Re: File No: CDR23-002, ED23-062, TS23-001 (PLAN23-081)

Development Application for Dominican Valley Housing Development including Conceptual Design Review, Environmental and Design Review, and Tentative Subdivision Map Application (APN 015-163-03)

Pursuant to Government Code section 65943 et seq., this letter informs you that the above referenced application is INCOMPLETE. The elements needed to make the application complete are detailed in the following sections of this letter. To facilitate the development review process, please include a detailed response letter with your resubmittal that addresses all items contained in this letter. Similarly, please provide written responses to the items identified as incomplete by other reviewers.

SUBJECT: Planning File #PLAN23-081 – Design Review Application: 50 Units Dominican Site

PRELIMINARY GRADING PLAN
DOMINICAN PARCEL A.P.N. (015-163-03)
MARIN COUNTY, CALIFORNIA

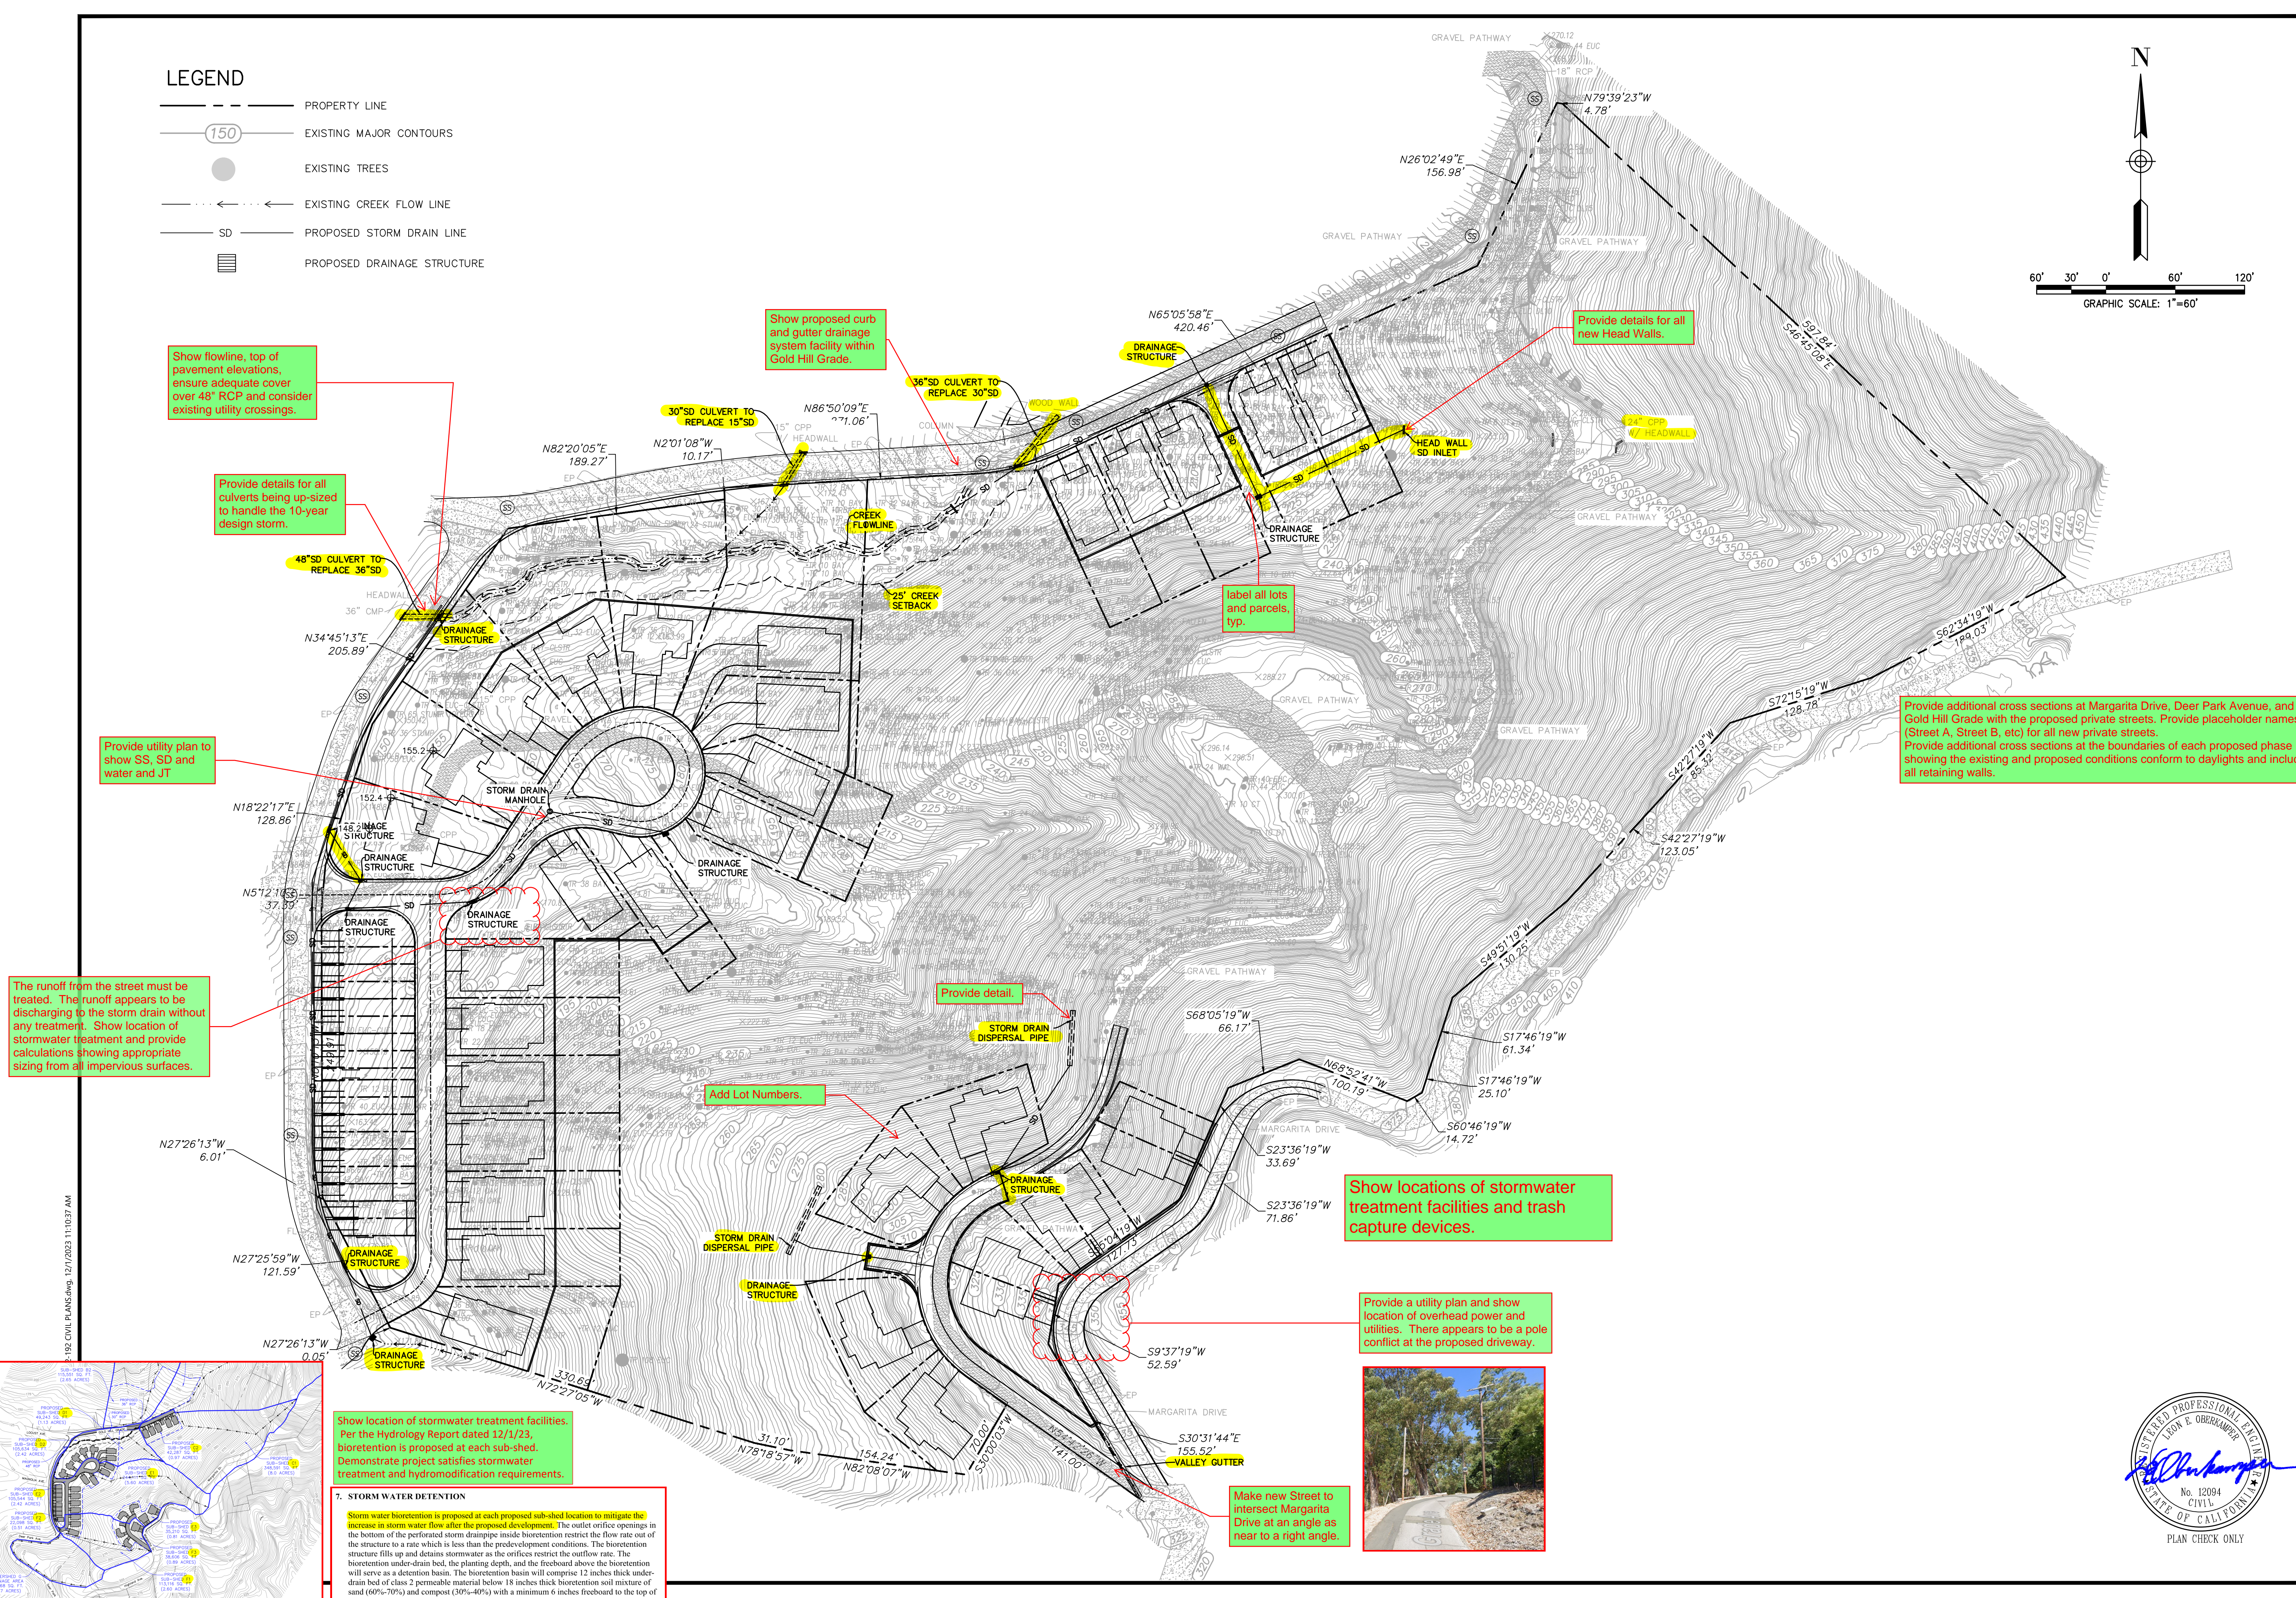
24. Sheet C4 (Preliminary Grading Plan)- Add lot numbers.
25. Add pad elevations and finish floor elevations to the Preliminary Grading Plan.
26. Provide details for all culverts being upgraded to handle the 10-year design storm. Since the culverts have been upsized, verify there is adequate cover over the proposed culverts as well as conflicts with existing utility crossings.

← Add Pad Elevation.

Add Lot numbers (typ.).

Add Pad Elevation.

Provide details for all culverts being up-sized to handle the 10-year design storm, typ.

Add Pad Elevations, typ.

Provide section for Deer Park Ave and Gold Hill Grade

Please provide cross sections through the multifamily homes and Deer Park Avenue to clarify conform between existing infrastructure and proposed improvements.

Show cross slope and direction of flow

Provide top of wall (TW) and bottom of wall (BW) elevations, typ.

15.02.030.g - Provide street name and grades of all roads

Provide additional cross sections at Margarita Drive, Deer Park Avenue, and Gold Hill Grade with the proposed private streets. Provide names for all new private streets. Provide additional cross sections at the boundaries of each proposed phase showing the existing and proposed conditions conform to daylights and include all retaining walls.

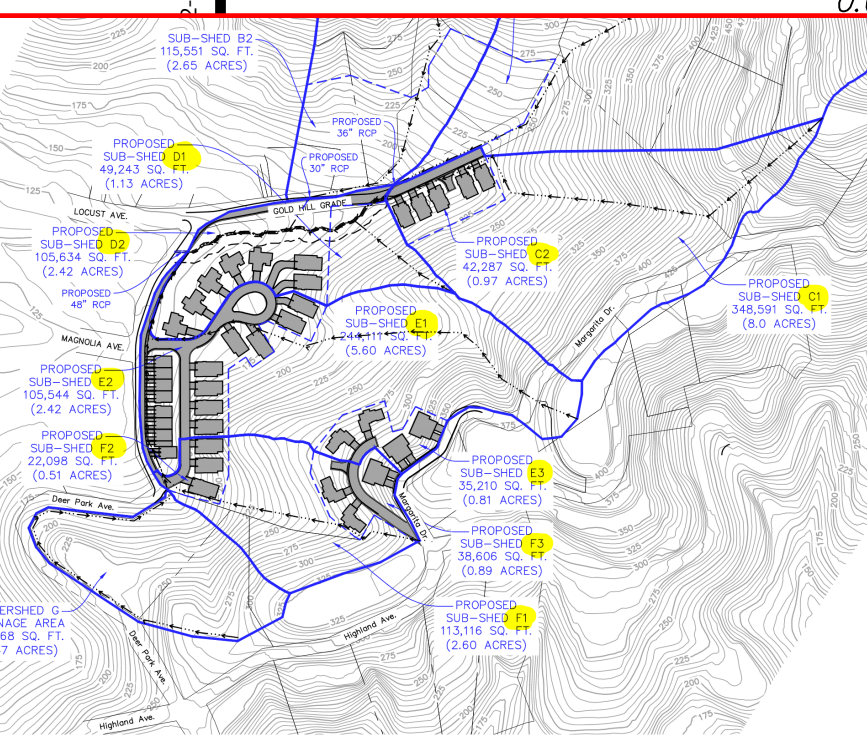
Show flowline, top of pavement elevations, ensure adequate cover over 48" RCP and consider existing utility crossings.

Provide details for all culverts being up-sized to handle the 10-year design storm.

Show proposed curb and gutter drainage system facility within Gold Hill Grade.

Provide details for all new Head Walls.

Provide utility plan to show SS, SD and water and JT.

The runoff from the street must be treated. The runoff appears to be discharging to the storm drain without any treatment. Show location of stormwater treatment and provide calculations showing appropriate sizing from all impervious surfaces.

Provide additional cross sections at Margarita Drive, Deer Park Avenue, and Gold Hill Grade with the proposed private streets. Provide placeholder names (Street A, Street B, etc) for all new private streets. Provide additional cross sections at the boundaries of each proposed phase showing the existing and proposed conditions conform to daylight and include all retaining walls.

Provide detail.

Add Lot Numbers.

Show locations of stormwater treatment facilities and trash capture devices.

Provide a utility plan and show location of overhead power and utilities. There appears to be a pole conflict at the proposed driveway.

Show location of stormwater treatment facilities. Per the Hydrology Report dated 12/1/23, bioretention is proposed at each sub-shed. Demonstrate project satisfies stormwater treatment and hydromodification requirements.
